PERFORMANCE
 SPECIFICATION

ACAD  The copyright of this drawing is reserved by HELLERMANN TYTON. It is issued on condition that it is not reproduced, copied or disclosed to a third party, either wholly or in part, without the consent of HELLERMANN TYTON.	Drawn MANDY ONG 23 Dec 2010	Scale: 1 ; 1 Reference: 14.1321
	Approved. EDWARD TAN 23 Dec 2010	Title T150RFT9 Drawing-No [SG10022-03] 18-0915-001-CSH 3.1 Format A4 Sheet 1 of 1

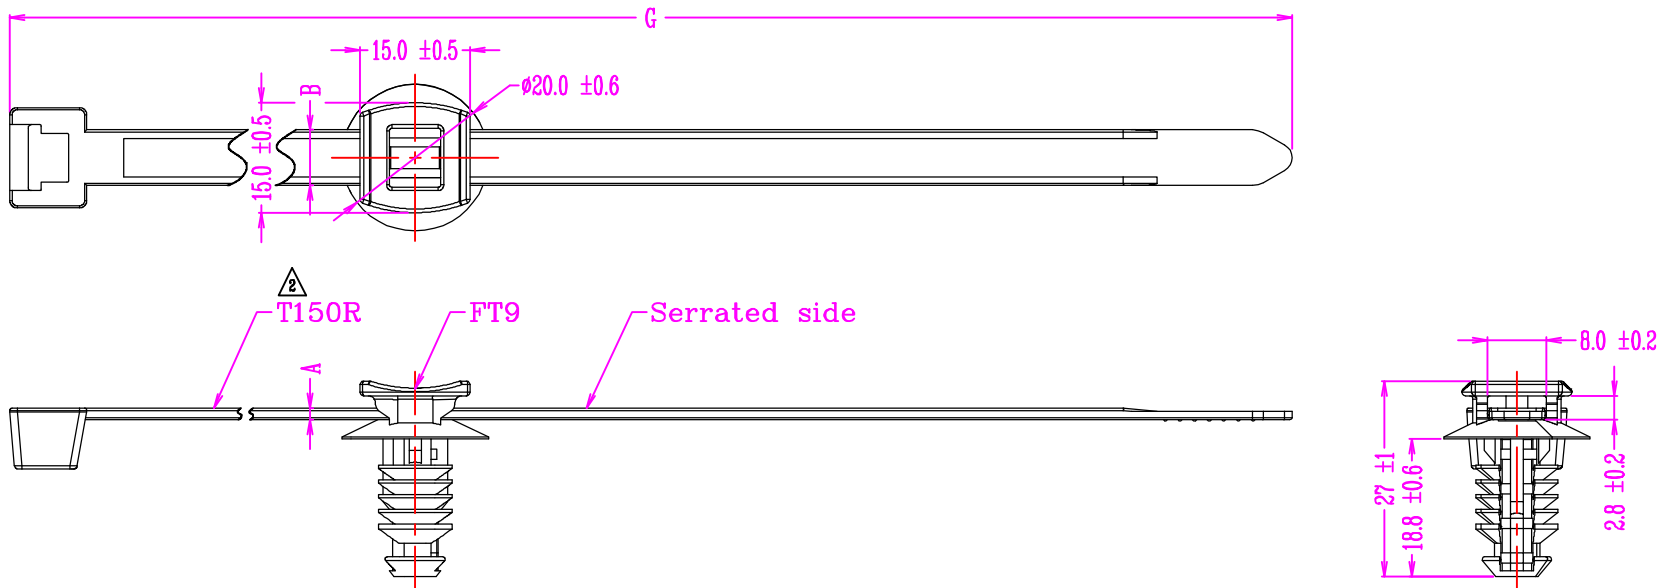
Revision Level		Revision Record	Changed	Date	Approval	Date
Part	Drawing					
	1	Updated pictogram	SIMON NG	17-Mar-16	Edward Tan	17-Mar-16
	1.1	Change hole size from $\varnothing 8.8 \sim \varnothing 9.4\text{mm}$ to $\varnothing 9.0 \sim \varnothing 10.6\text{mm}$.	SIMON NG	17-Mar-16	Edward Tan	17-Mar-16
	1.2	Change panel thickness from 4 ~ 8mm to 5.0 ~ 11mm.	SIMON NG	17-Mar-16	Edward Tan	17-Mar-16
	2	Correct typo error (From T50R to T150R).	SIMON NG	24-Oct-17	Edward Tan	24-Oct-17
	3	Updated pictogram and drawing template.	SIMON NG	25-Oct-19	Edward Tan	25-Oct-19
	3.1	Added HT Global project Number.	SIMON NG	25-Oct-19	Edward Tan	25-Oct-19
	3.2	Added cable tie dimensions chart.	SIMON NG	25-Oct-19	Edward Tan	25-Oct-19

Hole Size
 1.1 $\varnothing 9 \sim \varnothing 10.6\text{mm}$

Panel Thickness
 1.2 5 ~ 11mm
